**Re: SSD-102723479 Yiribana Logistics Estate
Response to IDC Integrated Water Cycle Management Review**

ENCLOSURE
IDC INTEGRATED WATER CYCLE MANAGEMENT REVIEW
21-030 YIRIBANA REVIEW V1.0 DATED 9 JUNE 2022

Integrated Water Cycle Management Review of the Yiribana Logistics Estate in the Mamre Road Precinct

RIPARIAN STORAGE Editor

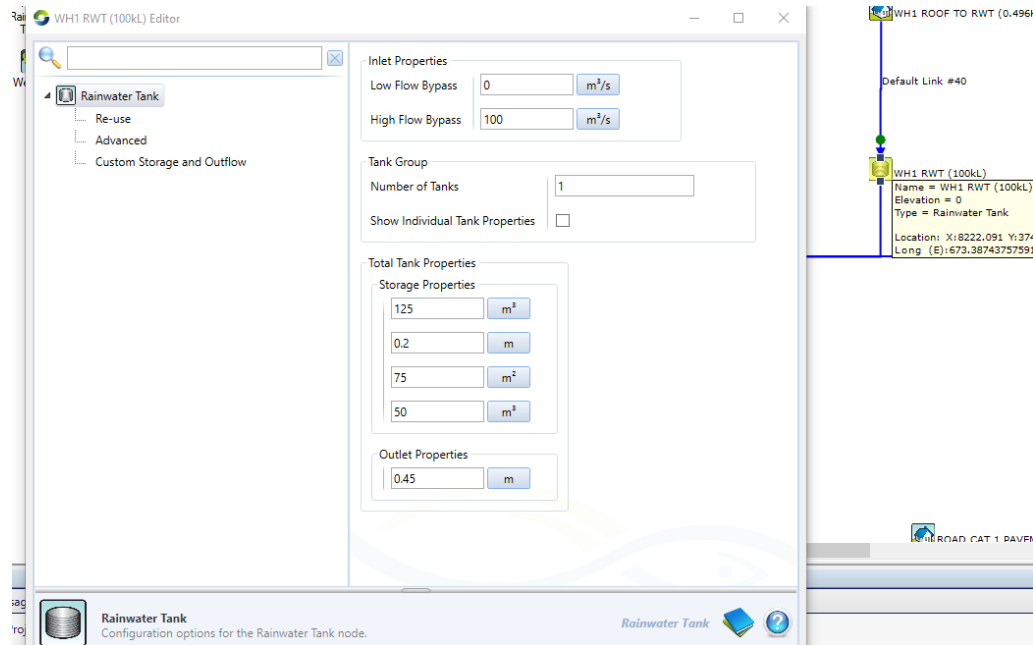
Re-Use (Irrigation)

The irrigation re-use for this node is distributed as PET, rather than PET-Rain. This should be updated and resubmitted in a revised model, along with a detailed breakdown of the 6,250kL/year of re-use with a landscape plan clearly showing the areas proposed for irrigation.

<p>Re-Use (Irrigation)</p> <p>The irrigation re-use for this node is distributed as PET, rather than PET-Rain. This should be updated and resubmitted in a revised model, along with a detailed breakdown of the 6,250kL/year of re-use with a landscape plan clearly showing the areas proposed for irrigation.</p>	<p>The irrigation re-use distribution used in the MUSIC modelling has been revised to PET-Rain as recommended. A detailed breakdown of the re-use has been provided in Section 7 of the <i>Water Cycle Management Strategy (inc. RtS Response)</i>, reference Co13874.04c.rpt</p>
